STAFF RECOMMENDATION
1407 Greenwood Avenue
November 19, 2018

Application: New Construction—Addition
District: Eastwood Neighborhood Conservation Zoning Overlay
Council District: 06
Map and Parcel Number: 08302004600
Applicant: Kaitlyn Smous, Nine12 Architects
Project Lead: Melissa Baldock, melissa.baldock@nashville.gov

<p>Description of Project: Application is to construct a rear dormer and a rear addition. The addition will be less than twenty feet (20') from an existing carport.</p> <p>Recommendation Summary: Staff recommends approval with the condition that staff approve the location of the HVAC and other utilities and all final material choices. With this condition, staff finds that the proposed addition meets Sections II.B. and III.B. of the Eastwood Neighborhood Conservation Zoning Overlay Design Guidelines.</p>	<p>Attachments A: Site Plan B: Elevations</p>
--	--

Figure 3 shows the window opening to be removed.

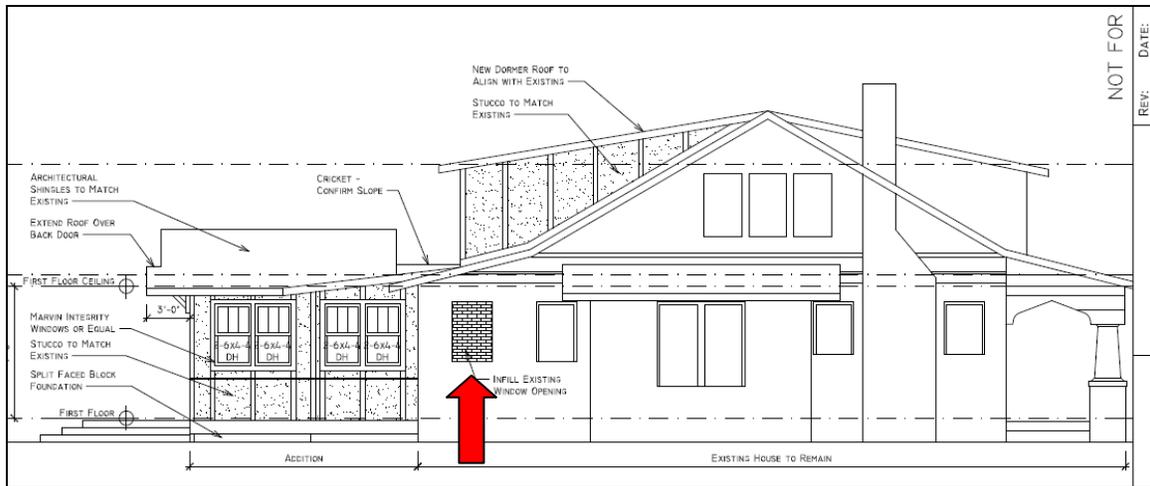
Demolition: The applicant intends to remove one existing window opening on the left façade of the principal building, which is considered partial demolition (Figure 3). Staff finds that the proposed removal of the window opening is appropriate, in this instance, because the window opening is located at the very rear of the left façade and is located behind a bay. The window is not highly visible from the street, and its removal will not affect the historic character of the historic house. Staff therefore finds that the removal of the window opening meets Section III.B.2 for appropriate demolition and does not meet section III.B.1 for inappropriate demolition.

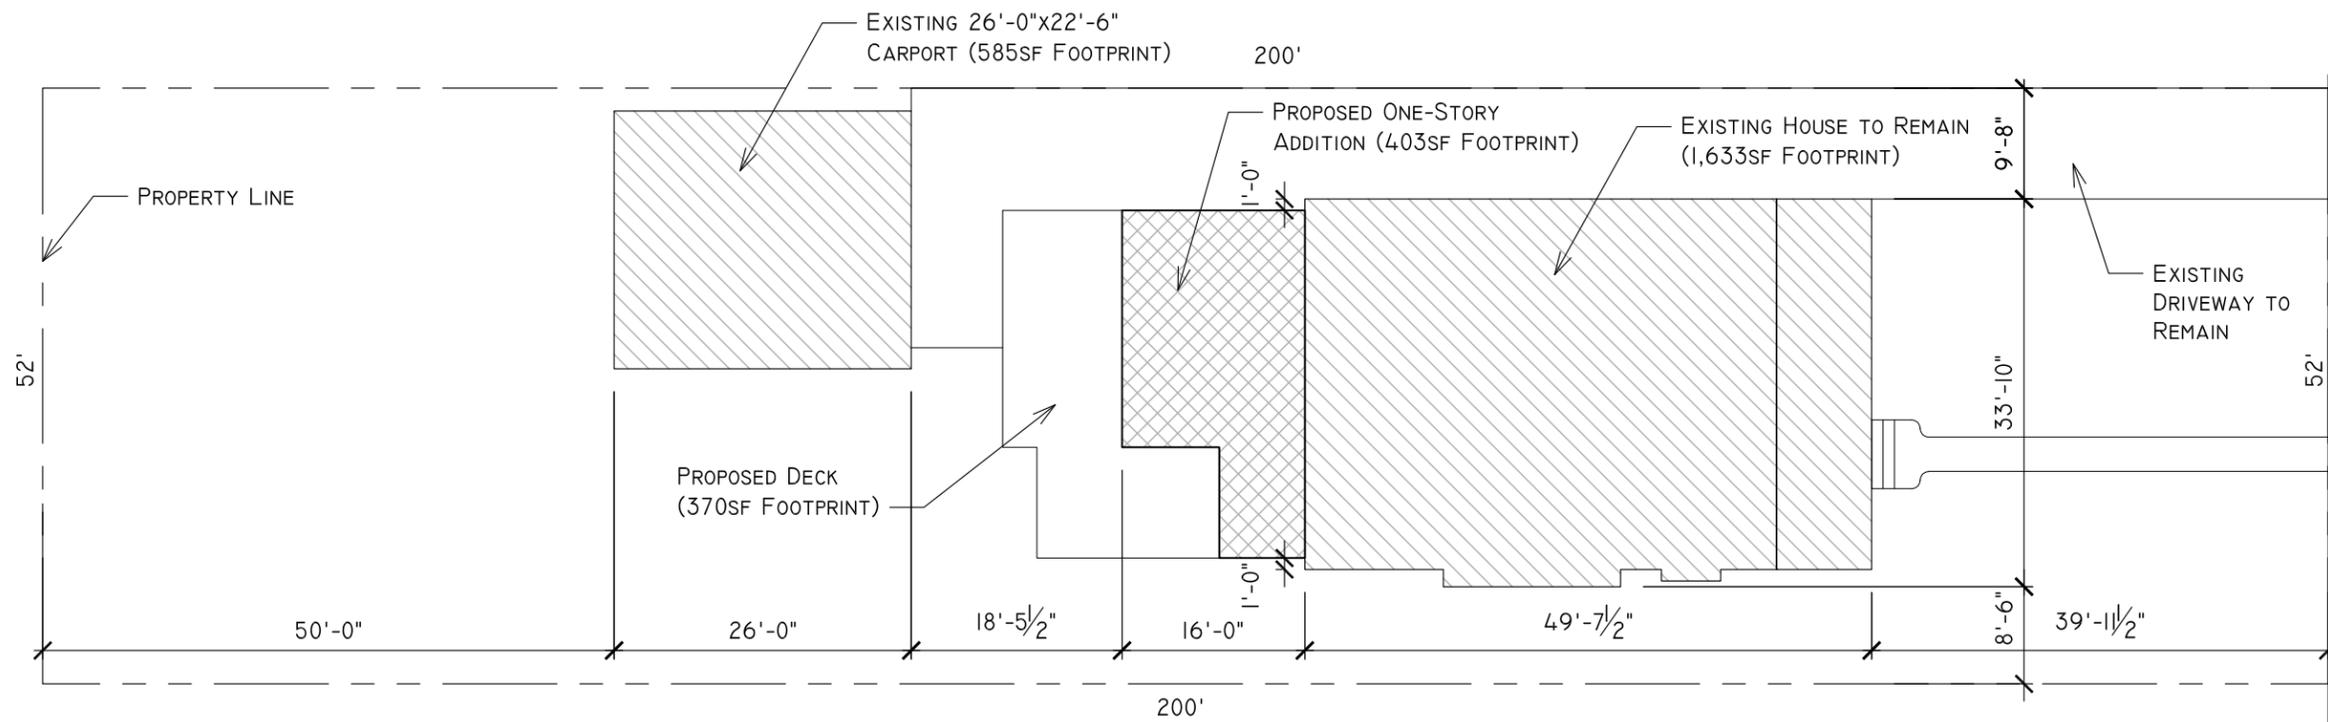
Roof form: The rear dormer will have a shed roof form with a 2/12 slope, which matches the existing rear dormer's roof and is an appropriate roof form for a rear dormer. The one-story rear addition has a gabled roof with a 4/12 slope. The design guidelines state that roof slopes should be a minimum of 6/12. However, staff finds this lower-sloped gable to be appropriate because it is on the rear and not visible from the street.

Typically, MHZC requires dormers to be set six inches (6") off of the ridge of the house. In this case, there is an existing dormer that meets the ridge of the house, and the proposed addition will expand the width of the dormer. Because the existing dormer is not set six inches (6") off the ridge, staff recognizes that it is not practical to have the

expanded part of the dormer set six inches (6”) off of the ridge. Staff therefor finds that the expanded dormer does not need to be offset six inches (6”) off of the ridge.

Staff finds that the proposed roof forms meet Sections II.B.1.e. and II.B.2. of the design guidelines.

SITE PLAN

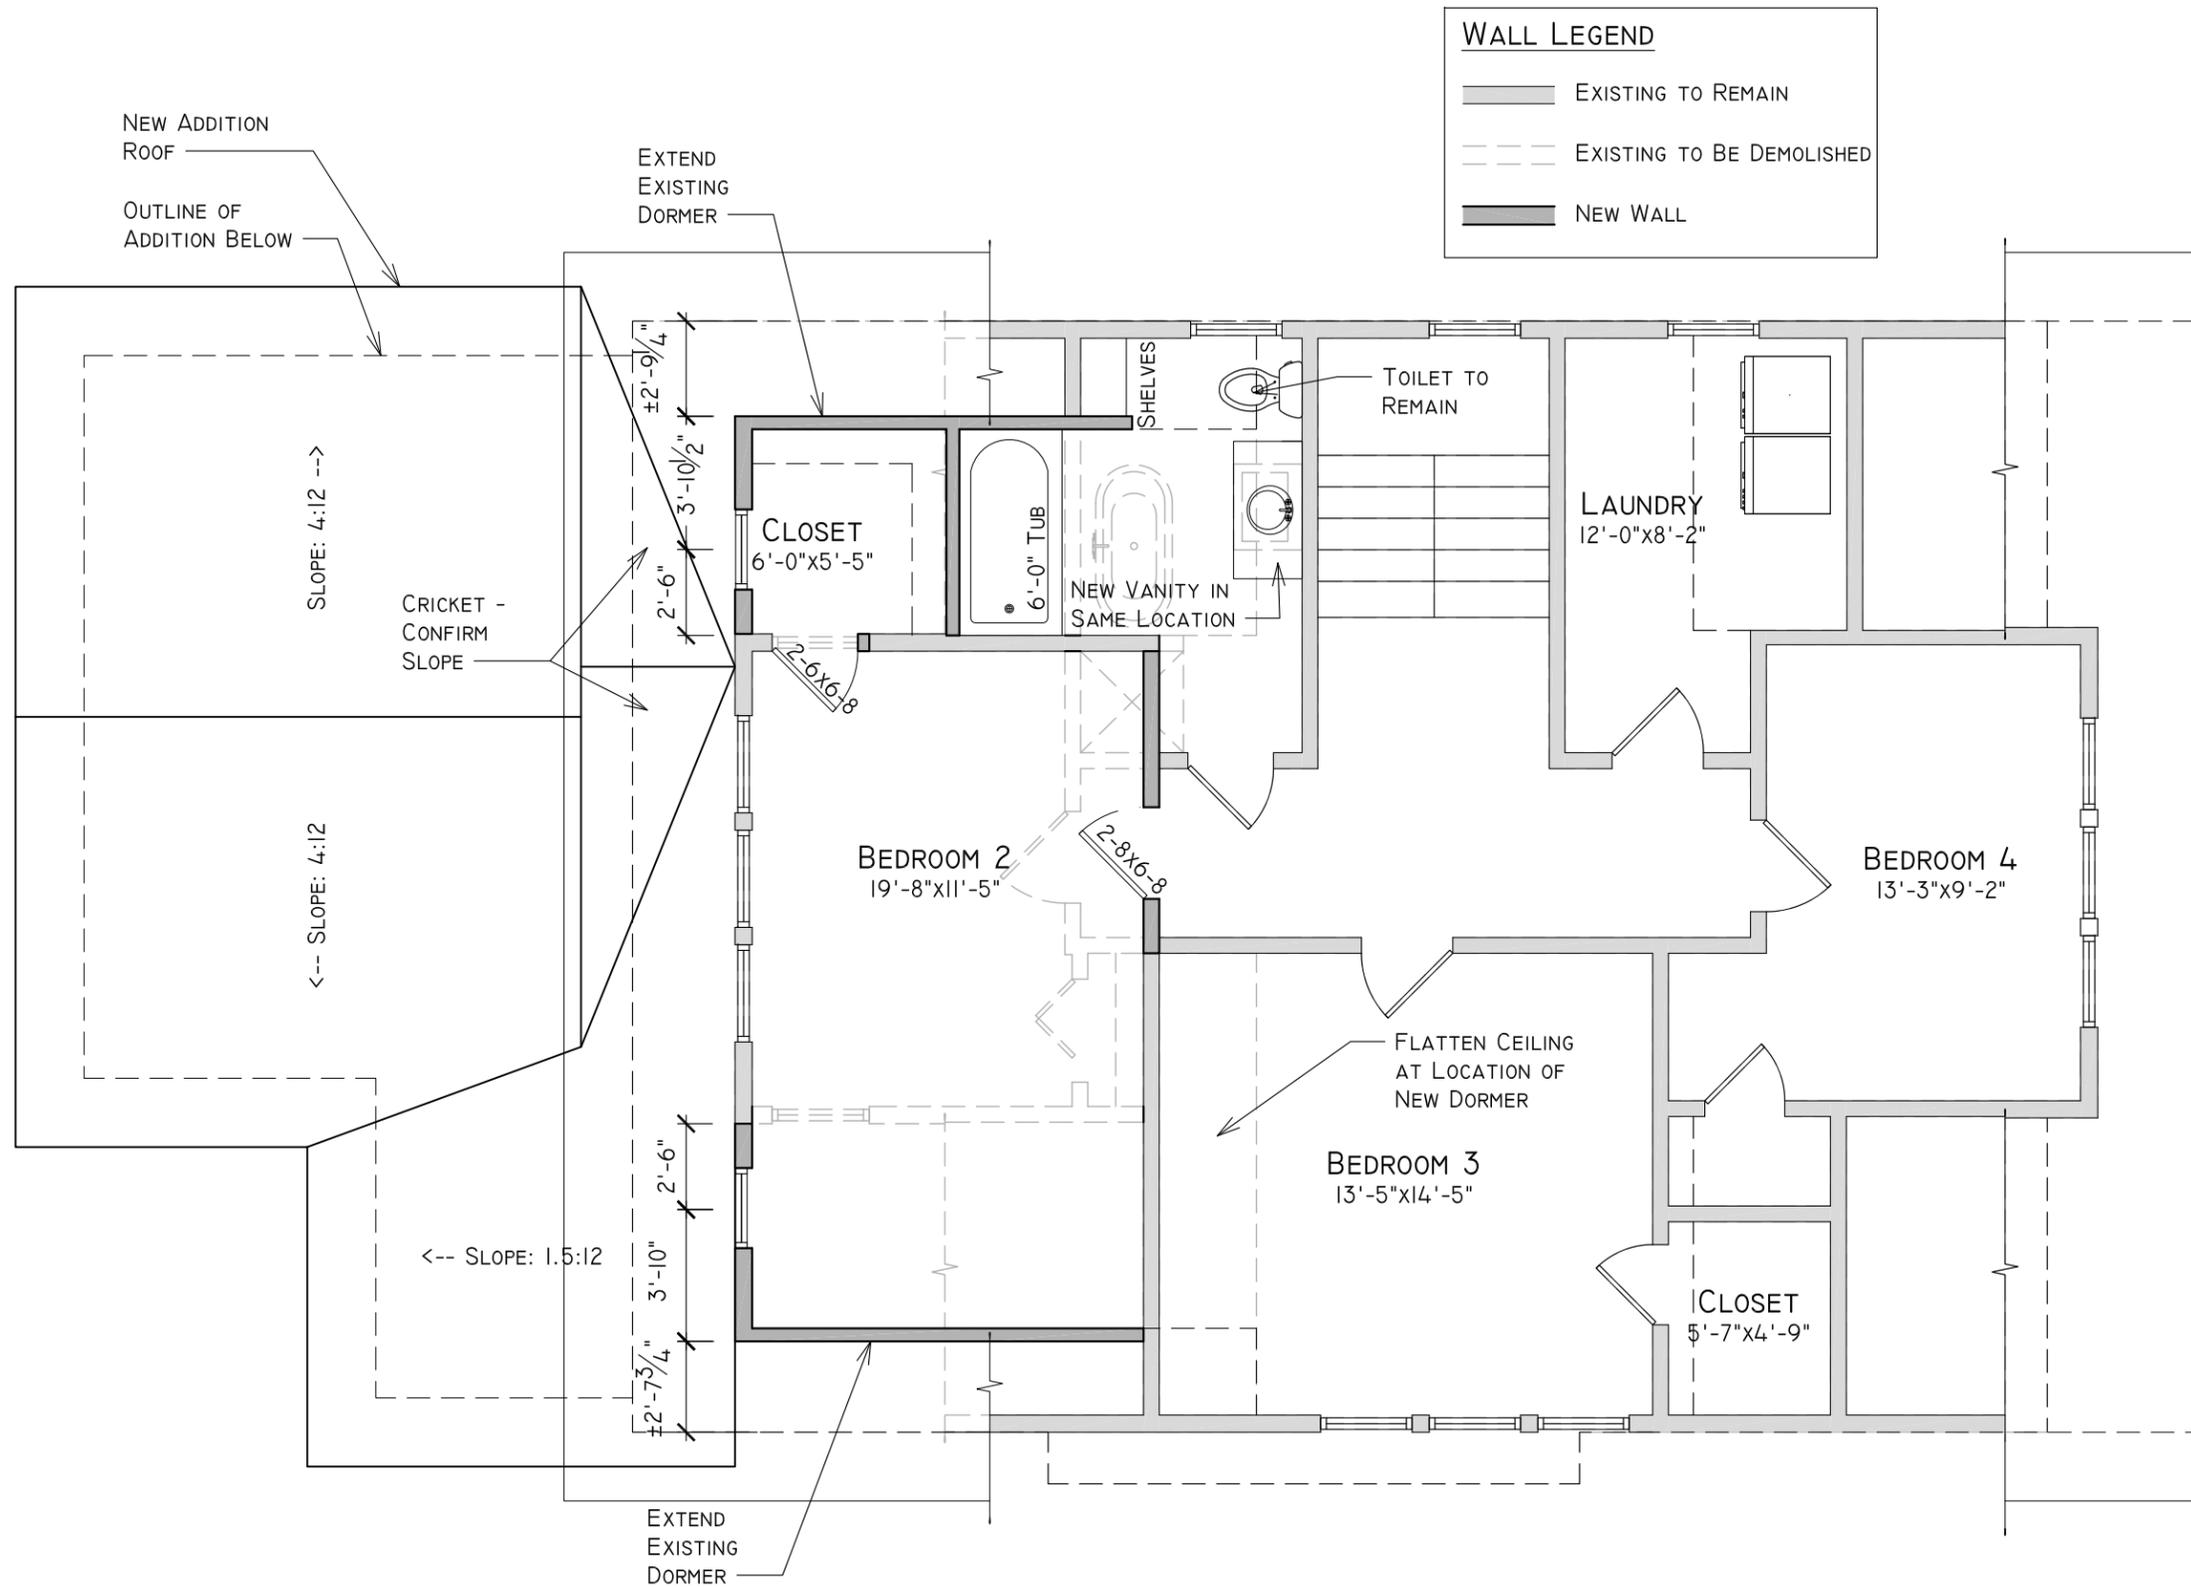
The addition will have a maximum depth of sixteen feet (16'), which does not include an uncovered deck that MHZC does not review. The design guidelines state, in italicized text, that there should be a minimum of twenty feet (20') of space in between the back of the house and an outbuilding. In this case, the addition will be just eighteen feet, five-and-a-half inches (18' 5-1/2") from the existing carport. Staff finds this to be appropriate because the carport is existing and is located in the middle of the lot rather than at the rear, towards the alley, which is what is most typical for this neighborhood. In addition, the proposed addition is modest in scale; it will be just eighteen inches (18") shy of the required twenty foot (20') distance between the two structures.

Setback & Rhythm of Spacing: The proposed addition will meet all base zoning setbacks. It will be over ten feet (10') from the left and right property lines and over ninety feet (90') from the rear property line. Because the addition is located entirely behind the historic house, it will not impact the historic rhythm of spacing on the street. Staff finds that the proposed addition meets Sections II.B.1.c. and II.B.2. of the design guidelines.
